Chapter 7 – Aquatic Ecosystems

AAP01-000-GEG-GGEN-00002

Project: Australia-Asia PowerLink

Figure 7-1: Surface water features (potential aquatic habitats) proximate to the Powell Creek Solar Precinct

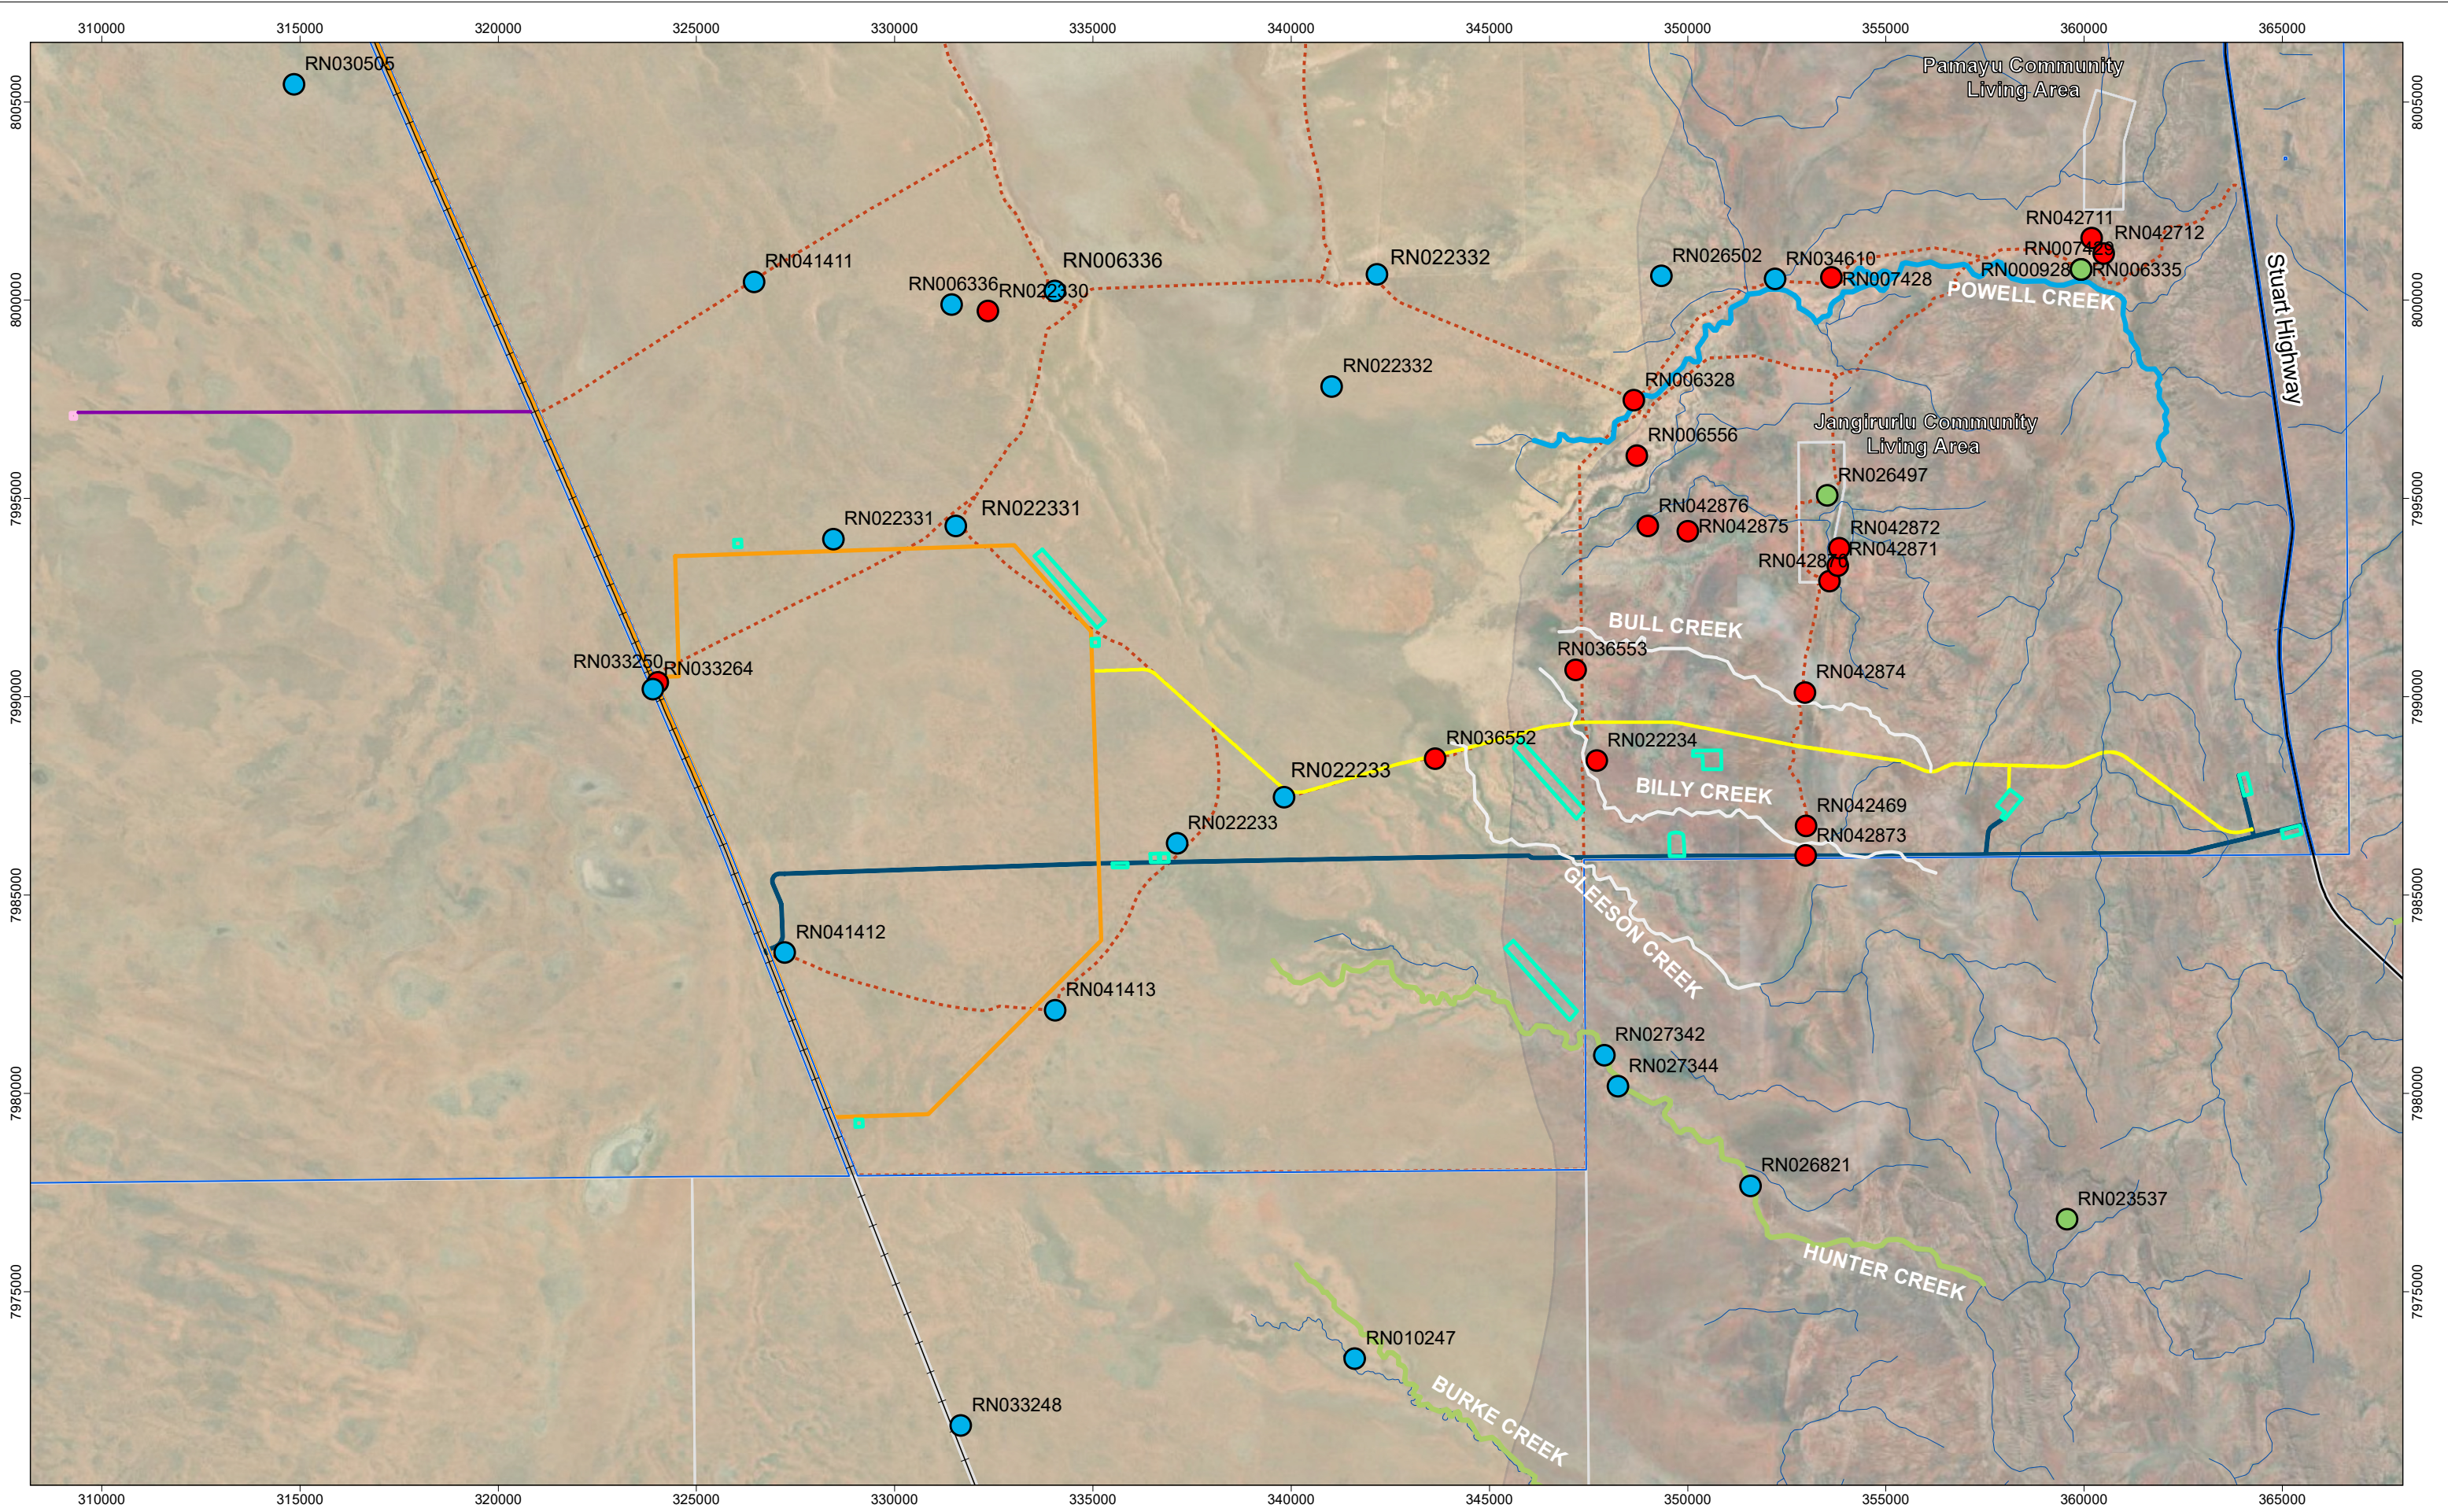
Section 6.3.1 of the draft EIS identifies that watershed changes from infrastructure at the Solar Precinct, due to land clearing and installation of solar panels, would not impact surface water flow regimes due to the design criteria for the Solar Precinct drainage network. These criteria provide for discharge at similar rates to preconstruction condition with no expected reduction in water volumes to the alluvial and flood plains surrounding Lake Woods.

The draft EIS states that construction activity and changes during operation (access tracks and pole pads) may cause changes to the structure of minor waterways and wetlands with residual changes to surface water flows.

The draft EIS does not provide ground truthed location and extent of land clearing required of riparian vegetation nor information about any trenching works near minor waterways and wetlands.

Provide information consistent with the scope of the action to address the Environmental decision-making hierarchy (Part 2 of EP Act) for road, infrastructure, drainage structures and trench construction, include measures and commitments to protect:

Surface water runoff will generally move, via overland flow, towards drainage depressions locally. More broadly, drainage across the Solar Precinct is towards the east and north, discharging to the floodplains around Lake Woods. There are no watercourses within the Solar Precinct. Within the Ashburton Ranges and alluvial flats adjacent to the Solar Precinct, there are several watercourses that flow north-east and discharge to the floodplains around Lake Woods. Within the Solar Precinct, earthworks will occur and where necessary, drainage will be installed to manage surface water. Drainage will be installed where required for the AI footprints and Access Roads, and flow paths will follow similar paths as pre-construction. All drainage will be constructed and maintained using the Best Practice ESC Guidelines (IECA, 2008).
